Summary and Analysis of Comments: Control of Emissions from Unregulated Nonroad Engines

EPA420-R-02-023
September 2002

Assessment and Standards Division
Office of Transportation and Air Quality
U.S. Environmental Protection Agency

Figure II.F-1: NTE Zone for Recreational CI Marine Engines

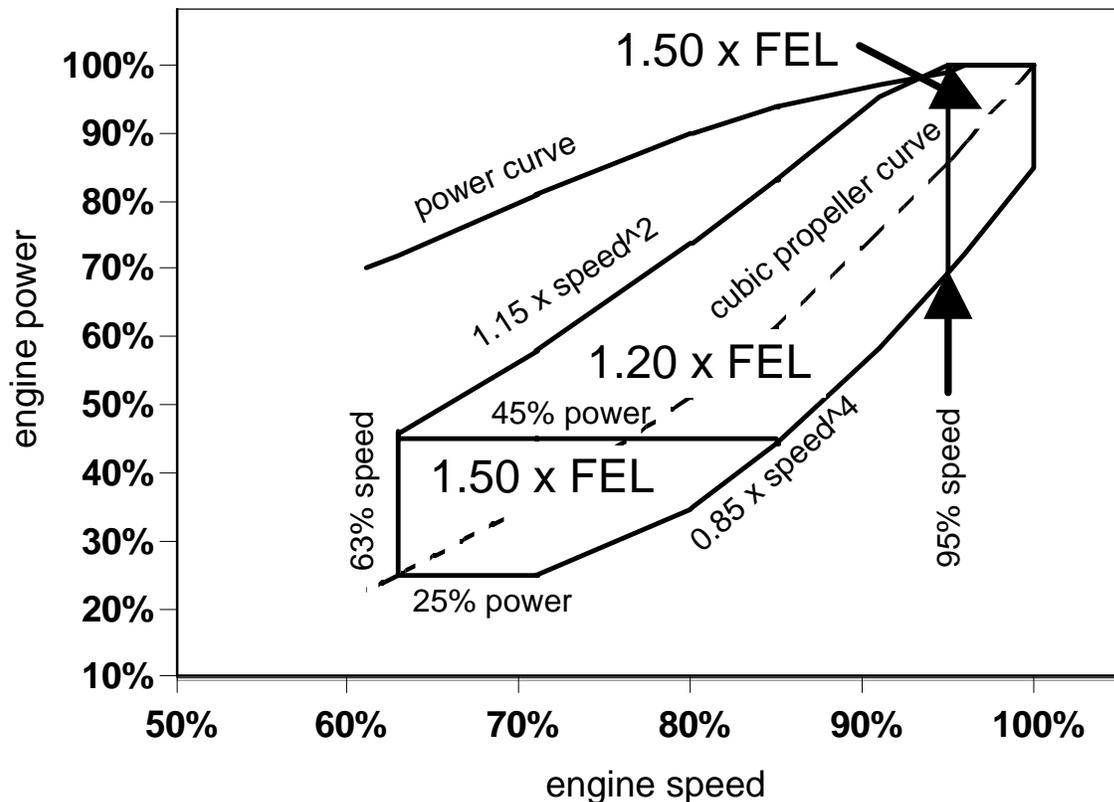
What Commenters Said::

The shape of the proposed NTE zone is presented in Table V.C-1 of the October 5,

2001 proposal (66 FR 51098). This zone is based on a range around the cubic propeller curve used in the ISO E5 duty cycle and is shown in Figure II.F-1. All operation below 63 percent of maximum test speed and all operation below 25 percent of maximum test power are excluded from this zone. In addition this NTE zone is split into three subzones with different emission limits. Only steady-state operation is included.

Figure II.F-4: Illustration from EMA Comments (NTE Zones Added)

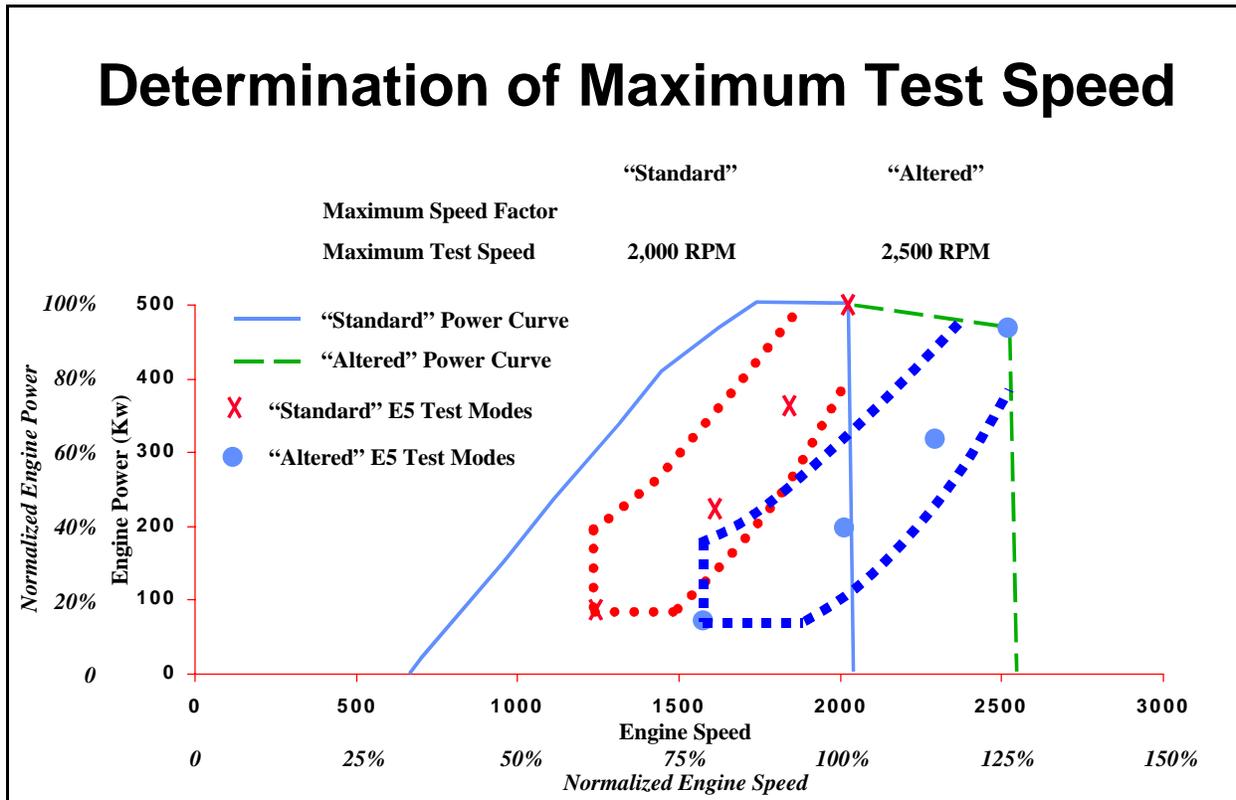
EMA's own discussion on defining the maximum test speed supports the need for including expanded operation beyond the theoretical propeller curve. They stated that a manufacturer could circumvent the standards by using a different maximum test speed than the recommended rated speed for the boat builder. This also provides an illustration of how the engine operation on a vessel could be sensitive to improper matching of the propeller and engine with a vessel. Figure II.F-4 shows the illustration submitted by EMA. We added the NTE zones for the two maximum test speeds to this illustration. Although this is likely a worst-case scenario, it supports the need for a NTE zone that is expanded beyond a theoretical propeller curve.

Even if the propeller were ideally matched for typical operation of a vessel (selecting the proper propeller type, size, and pitch for a given vessel form and size), changes in vessel loading and weather can affect the actual loading of the engine. The loading of the vessel can affect the actual propeller curve in two ways: changing the effective pitch of the propeller in the water and affecting the boat's resistance in the water. Weather can affect the propeller curve through wind and waves acting on the vessel. When propellers are matched to a vessel, they are designed to operate on a specific angle in the water; changing this angle by changing the angle the boat sits in the water will affect propeller loading at a given speed. The condition of the propeller can affect its operating characteristics. Also, changing the resistance on the boat can affect the propeller curve by changing the load on the propeller at a given speed. This is supported by the discussion of variables that affect engine operation discussed in comments made by Hatteras Yachts. Thus a vessel can be expected to operate differently than predicted by a single propeller curve associated with that vessel.
